# SITE/SOIL EVALUATION FOR ON-SITE WASTEWATER

To: Kent Pierce  
From: Mike Eaker

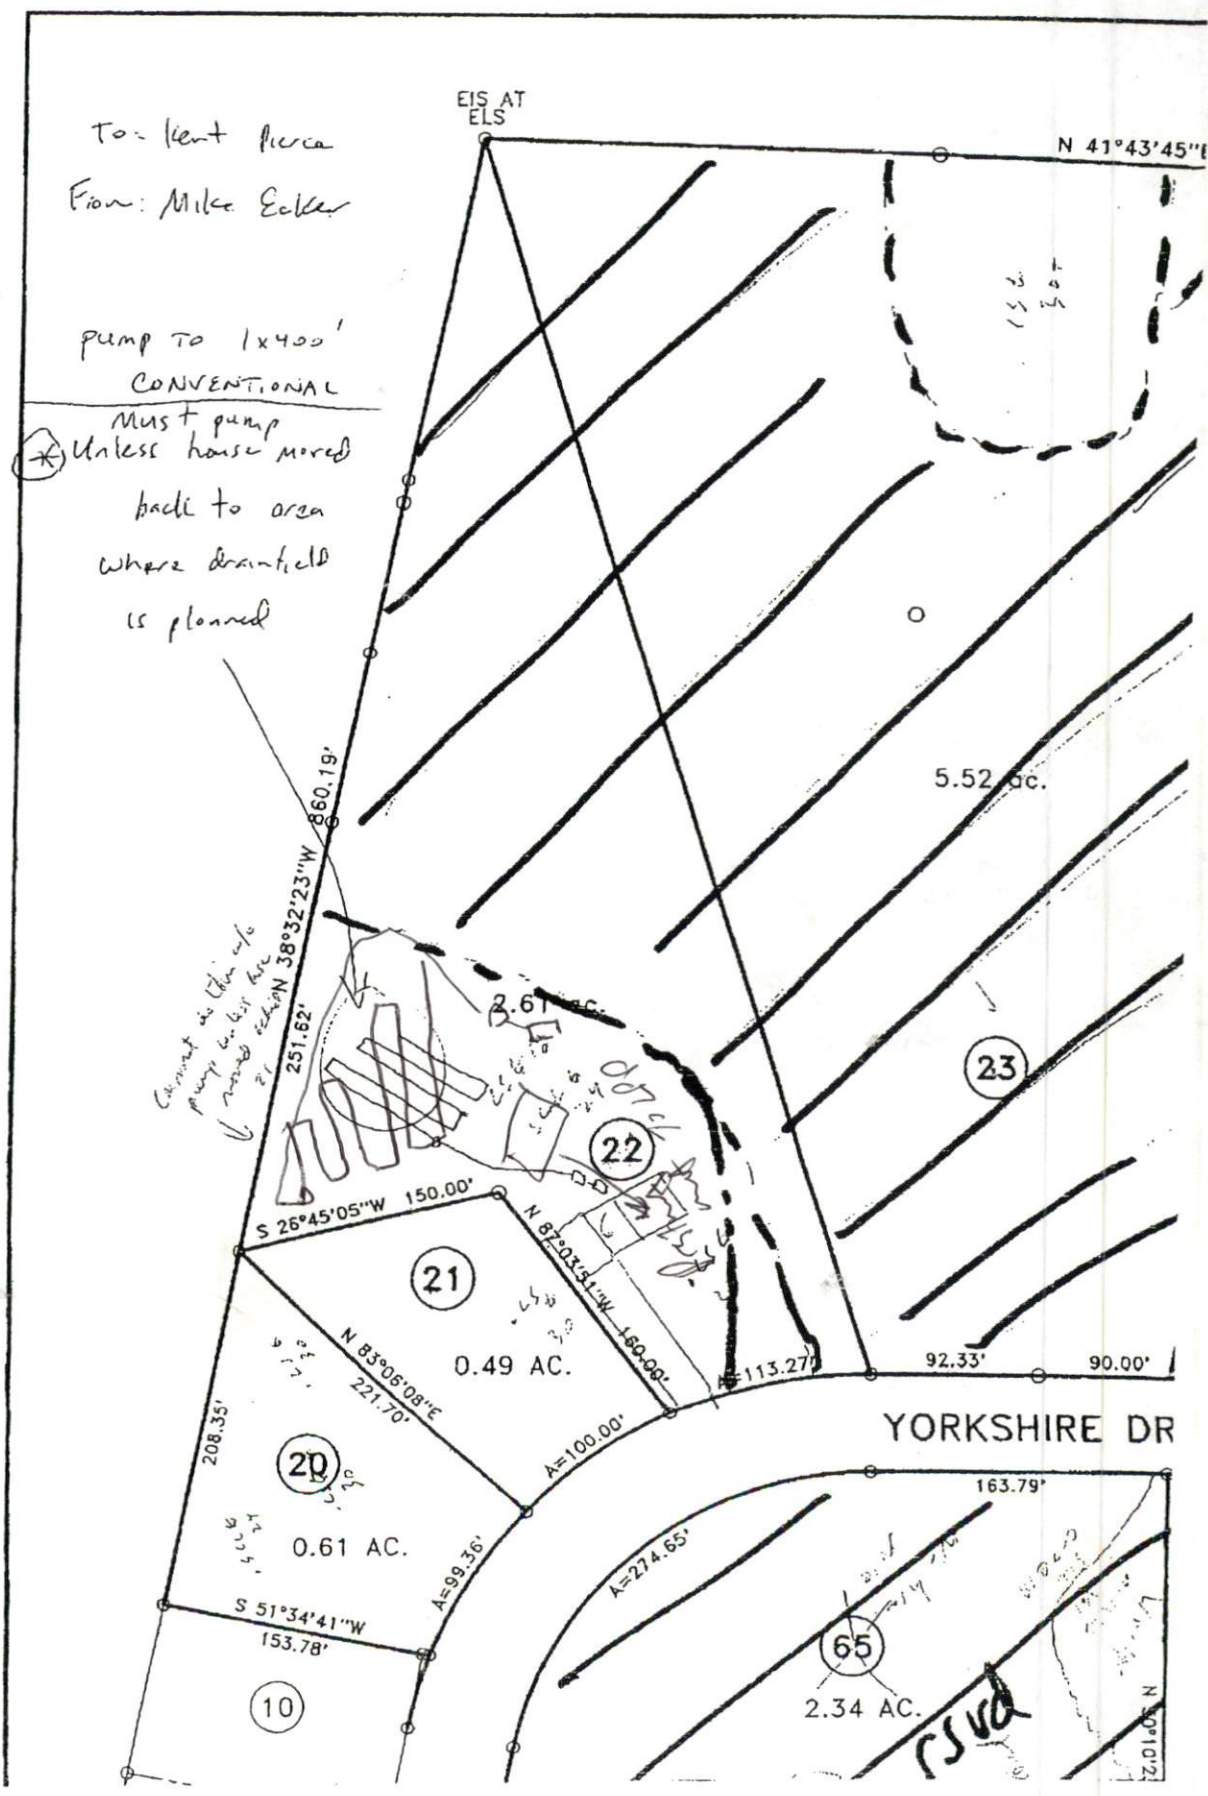
pump to 1x400'  
CONVENTIONAL

⊗ Must pump  
back to area  
where drainfield  
is planned

Comment on this info  
pump to be here  
moving station
